# UNITED STATES PATENT AND TRADEMARK OFFICE

APPLICATION NO.	FILING DATE	FIRST NAMED INVENTOR	ATTORNEY DOCKET NO.	CONFIRMATION NO.
10/814,348	04/01/2004	Serge Bisson	44117-138	5328

**Office Action Summary**

## **DETAILED ACTION**

Exhibit 1: Bitel '773 Figures 1 and 3

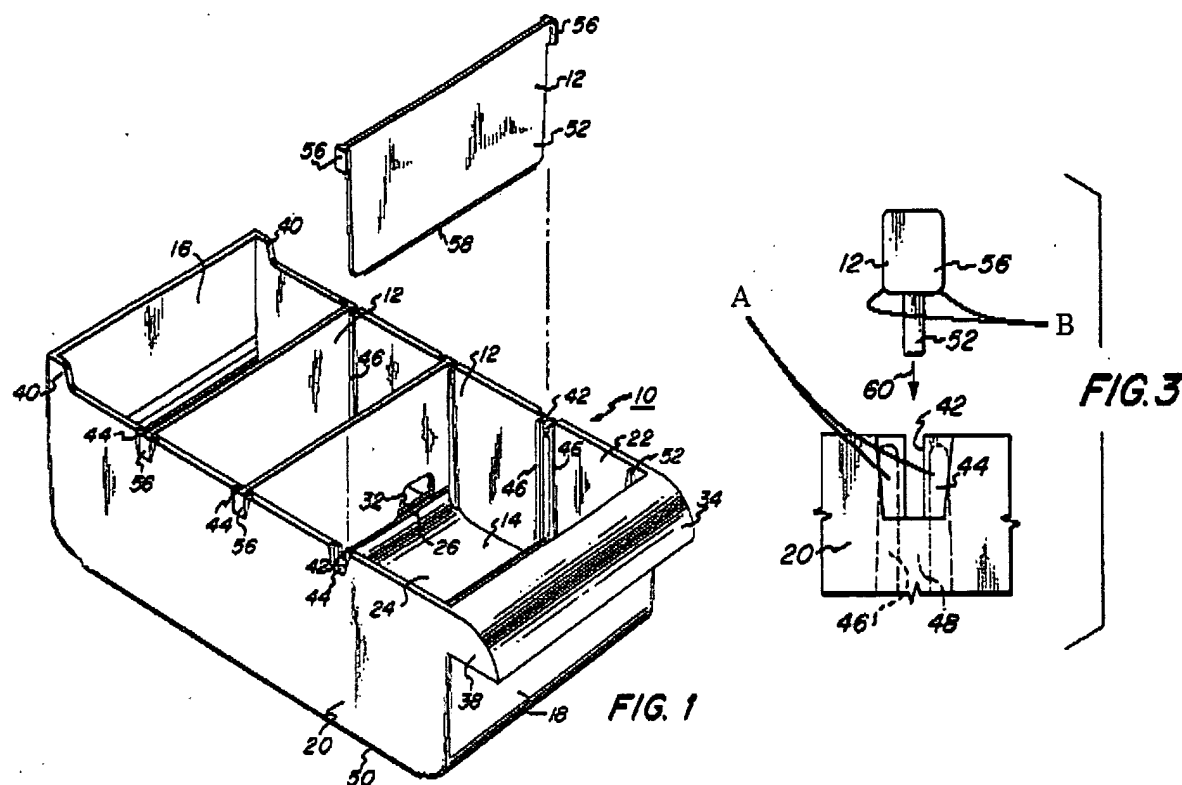
7. Claims 1, 2, 5-8, 13, 14, 16-19, and 24 are rejected under 35 U.S.C. 102(b) as being anticipated by Bitel (US Patent Number 4577773). Bitel (Figures 1 and 3) discloses a partitioning/fastening arrangement for a partitioning wall in a drawer comprising: a partitioning wall (12) having a pair of elongated blades (56) in the partitioning wall [Note that the limitation "punched" is a product by process limitation. The product itself does not depend on the process of making it. The limitation "punched" would not be expected to impart distinctive structural characteristics to the device.] and projecting sideways from the partitioning wall adjacent ends thereof at a predetermined height of the partition wall; and opposite connecting elements (42, 44) respectively projecting from the support walls at heights matching with the height of the blades of the partitioning wall when the partitioning wall is in operative position between the support walls (20, 22), the connecting elements having retaining channels (42) in which the ends of the partitioning wall are uprightly slideably engageable, the retaining channels having opposite side locking lips (viewed as A in Exhibit 1) forming guiding slots for passage of a section of the partitioning wall extending between the connecting elements, the blades of the partitioning wall respectively press-fitting against inner sides of the channels behind the locking lips when the partitioning wall is in the operative position.

8. Regarding claims 2 and 14, Bitel further discloses opposite support elements (46) respectively projecting from the support walls at another height with respect to the connecting elements, the support elements respectively having guiding slots (48) in which the ends of the partitioning wall are slideably engageable, the guiding slots of the

support elements being aligned with the guiding slots of the retaining channels of the connecting elements (see Figure 3).

9. Regarding claims 5 and 16, Bitel further discloses the support elements extend below the connecting elements (see Figure 1).

10. Regarding claims 6 and 17, as best understood, Bitel further discloses the blades have lower ramp-like surfaces (viewed as angles B) facilitating insertion of the blades in the retaining channels.

11. Regarding claims 7 and 18, Bitel further discloses the blades extend directly at the ends of the partitioning wall.

12. Regarding claims 8 and 19, Bitel further discloses a seating flange (58) projecting from a bottom end of the partitioning wall and extending laterally with respect thereto.

13. Regarding claim 24, as best understood, Bitel further discloses the support walls (20, 22) comprise peripheral walls of the drawer (10).

**Exhibit 2:** Hollenstein '742 Figures 1 and 2

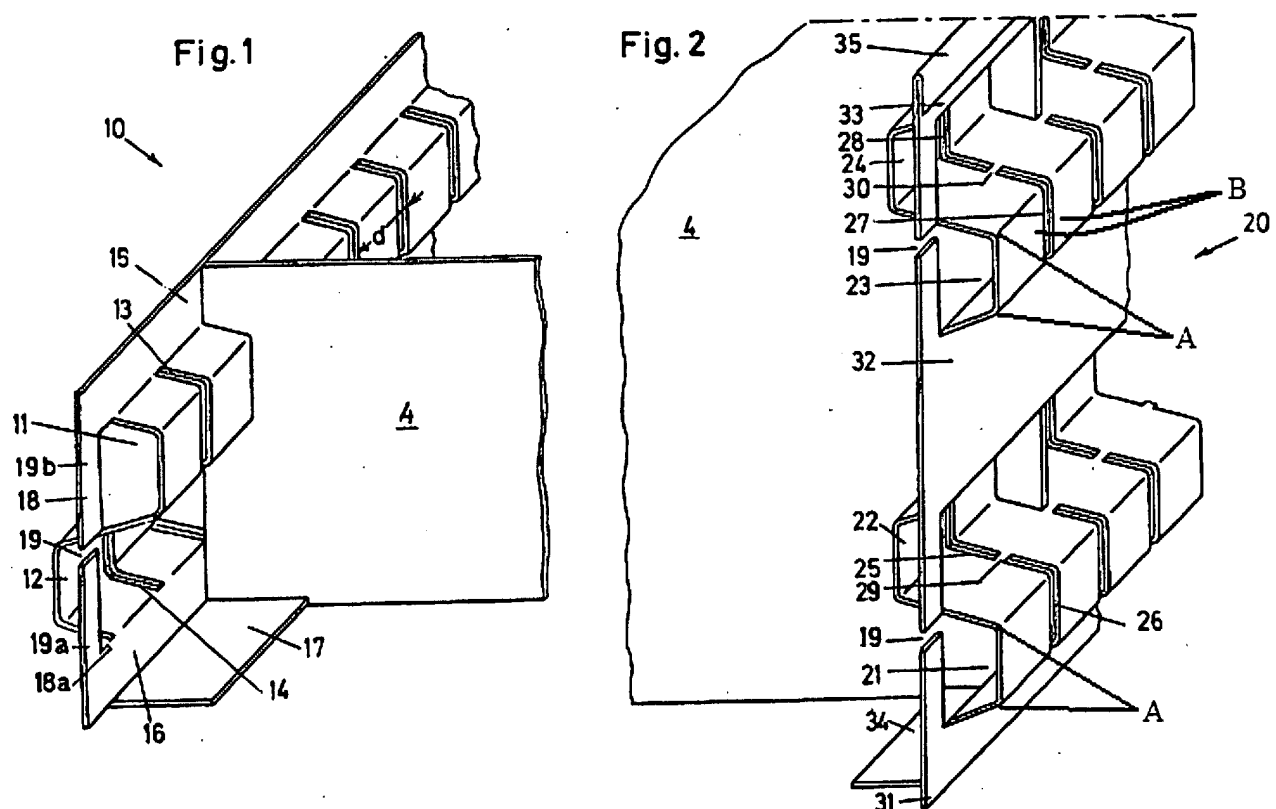
15. Claims 1-4 and 9-15 are rejected under 35 U.S.C. 103(a) as being unpatentable over Hollenstein (Swiss Patent Number 644742) in view of Moore (US Patent Number 3433548). Hollenstein (Figures 1 and 2) discloses a drawer partition system comprising a partitioning wall (4); and opposite connecting elements (23, 27) respectively projecting

from support walls (32, note that while only one support wall is shown, it is inherent that more would be present in a drawer arrangement) at heights matching with the height of a partitioning wall (4) when the partitioning wall is in operative position between support walls, the connecting elements having retaining channels (27) in which the ends of the partitioning wall are uprightly slideably engageable, the retaining channels having opposite side locking lips (viewed as B in Exhibit 2) forming guiding slots for passage of a section of the partitioning wall extending between the connecting elements.

Hollenstein does not disclose a pair of blades in the partitioning wall. Moore (Figure 1) discloses a partition arrangement for a drawer including elongated blades (17) projecting sideways from a partitioning wall (16) and engaging retaining channels (19). Accordingly, it would have been obvious to one of ordinary skill in the art at the time the invention was made to modify Hollenstein's partitioning system to comprise elongated blades on both sides of the partitioning wall as taught by Moore because this arrangement would allow for more control over the fit of the partitions.

16. Regarding claims 2 and 14, Hollenstein further discloses opposite support elements (21, 26) respectively projecting from the support walls at another height with respect to the connecting elements, the support elements respectively having guiding slots (26) in which the ends of the partitioning wall are slideably engageable, the guiding slots of the support elements being aligned with the guiding slots of the retaining channels of the connecting elements (see Figure 2).

17. Regarding claims 3 and 15, Hollenstein further discloses the connecting (23, 27) and support (21, 26) elements comprising longitudinal extrusions (21, 23) made in the

support walls (32) and projecting on a side thereof, with retaining channels (27) and guiding slots (26) being made in and extending crosswise to the extrusions of respective ones of the connecting and support elements.

18. Regarding claim 4, Hollenstein further discloses the extrusions have substantially rounded upper and lower surfaces (viewed as curves A in Exhibit 2) for joining the support walls.

19. Regarding claim 9, Hollenstein further discloses an additional connecting element (24) projecting from at least one of the support walls at a height to receive a partitioning wall (4), the additional connecting element being like the connecting element already made in said at least one of the support walls but projecting on a side of said at least one of the support walls opposite to a side on which the connecting element already made in said at least one of the support walls projects (see Figure 2).

20. Regarding claim 10, Hollenstein further discloses an additional connecting element (24) projecting from at least one of the support walls at a height to receive a partitioning wall (4), and an additional support element (22) projecting from said at least one of the support walls at another height with respect to the additional connecting element, the additional connecting and support elements being respectively like the connecting and support elements (21, 23, 26, 27) already made in said at least one of the support walls but projecting on a side of said at least one of the support walls opposite to a side on which the connecting and support elements already made in said at least one of the support walls project (see Figure 2).

21. Regarding claim 11, Hollenstein further discloses the connecting elements of said at least one of the support walls extend successively one above the other, and the support elements of said at least one of the support walls extend successively one above the other (see Figure 2).

22. Regarding claim 12, Hollenstein further discloses the connecting and support elements comprise longitudinal extrusions made in the support walls and projecting on respective sides thereof, the retaining channels being made in and extending crosswise to the extrusions of the connecting elements, the guiding slots of the support elements being made in and extending crosswise to the extrusions of the support elements.

Kleinert et al. '215 Figures 1 and 2

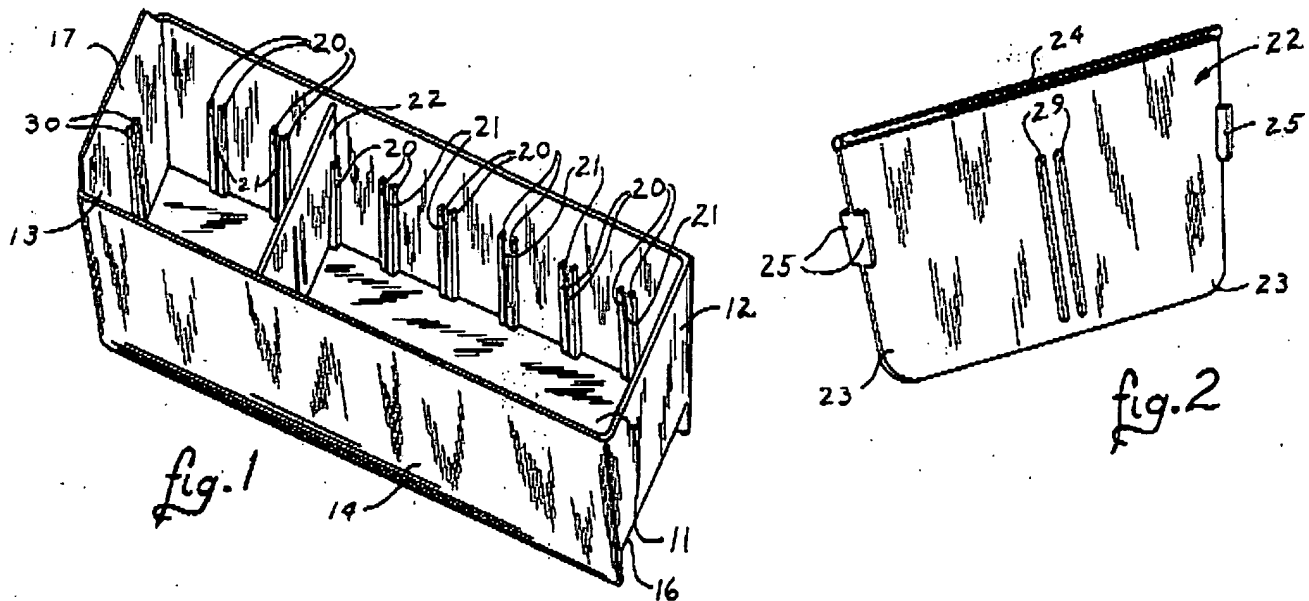
23. Claims 20-23, as best understood, are rejected under 35 U.S.C. 103(a) as being unpatentable over Hollenstein in view Moore and further in view of Kleinert et al. (US Patent Number 4436215). Hollenstein, when modified by Moore as described above, discloses a partitioning system as recited in claim 14 as well as connecting and support elements as recited in claims 20-23, but does not disclose similar connecting and support elements on a partitioning wall in addition to the support walls. Kleinert (Figures 1 and 2) discloses a partition system for a drawer including a partitioning wall (22) comprising connecting/support elements (29) like the connecting/support elements (30) of his support walls (13, etc.), the partitioning wall capable of forming a support wall for another partitioning wall. Accordingly, it would have been obvious to one of ordinary skill in the art at the time the invention was made to modify Hollenstein's partitioning wall, in his partitioning system previously modified by Moore, to include

connecting/support elements on his partitioning wall as taught by Kleinert because this would allow a more partitions to be added to the system and increase its versatility.

Dunham '504 Figure 1

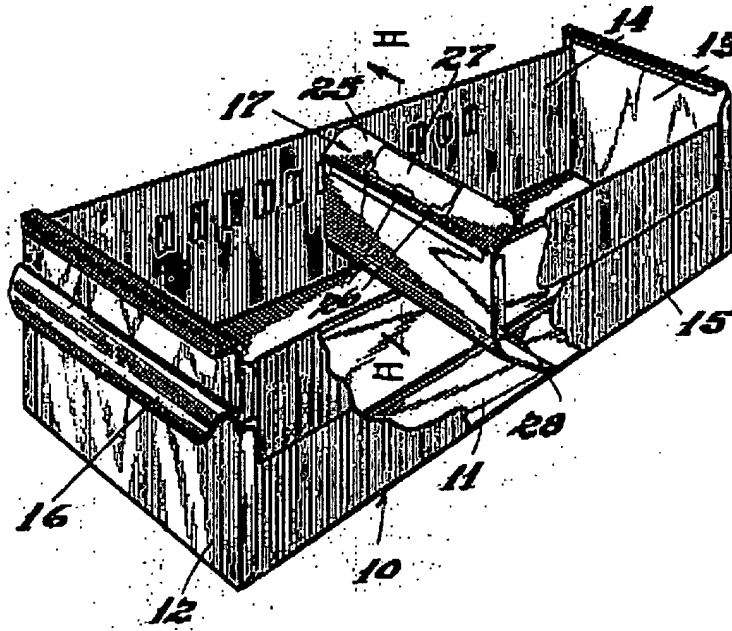
24. Claim 25 is rejected under 35 U.S.C. 103(a) as being unpatentable over Bitel in view of Dunham (US Patent Number 3227504). Bitel discloses a partitioning system as recited in claim 13 but does not include a label holding flange on the partitioning wall. Dunham (Figure 1) discloses a divider system for a drawer (10) including a partitioning wall (17) having a label holding flange (25) slantingly projecting from a top end of the partitioning wall. Accordingly, it would have been obvious to one of ordinary skill in the art at the time the invention was made to modify Bitel's partitioning wall to include a

label holding flange because this arrangement would provide a convenient mounting area for an indicia bearing label or card to help organize contents of the drawer.
